REMARKS

AMENDMENTS TO THE DRAWINGS

ANNOTATED MARKED-UP DRAWINGS

~~Fig. 6~~

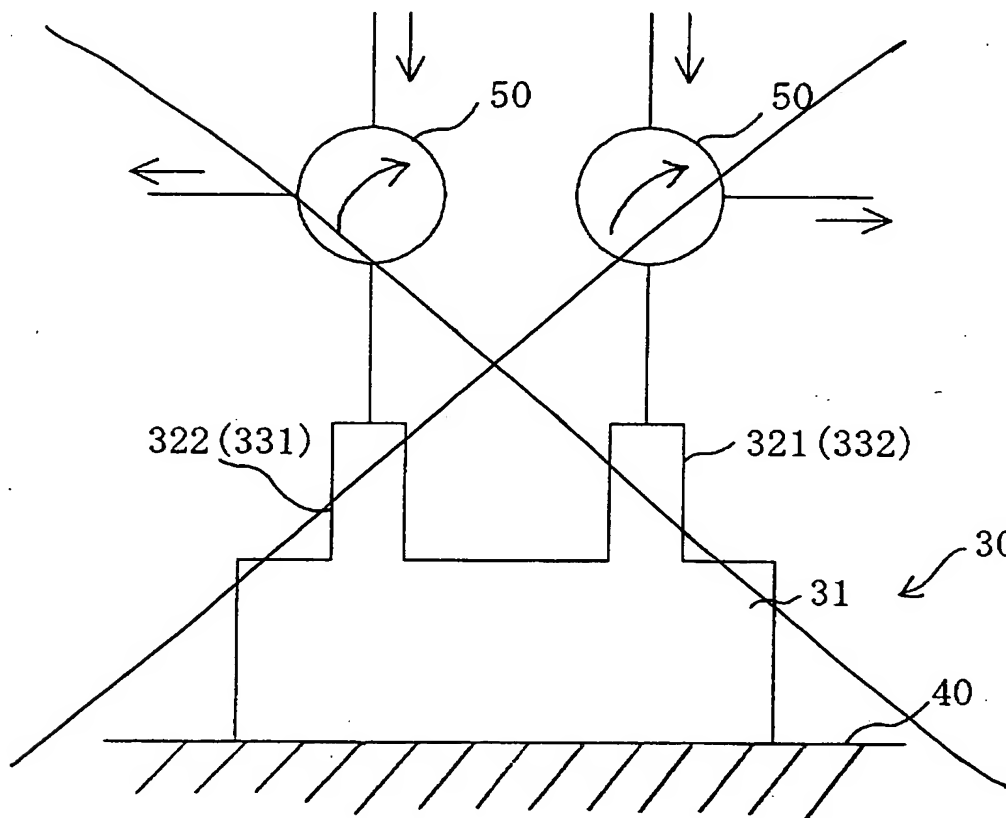
The drawings have been amended as described below. Original FIGURE 6 has been deleted and replaced with a new FIGURE 6. New FIGURE 6 illustrates the subject matter of original FIGURE 6 in an alternative manner which is believed to be more acceptable to the Examiner.

ORIGINAL FIGURE 6
REPLACED WITH NEW
FIGURE 6.
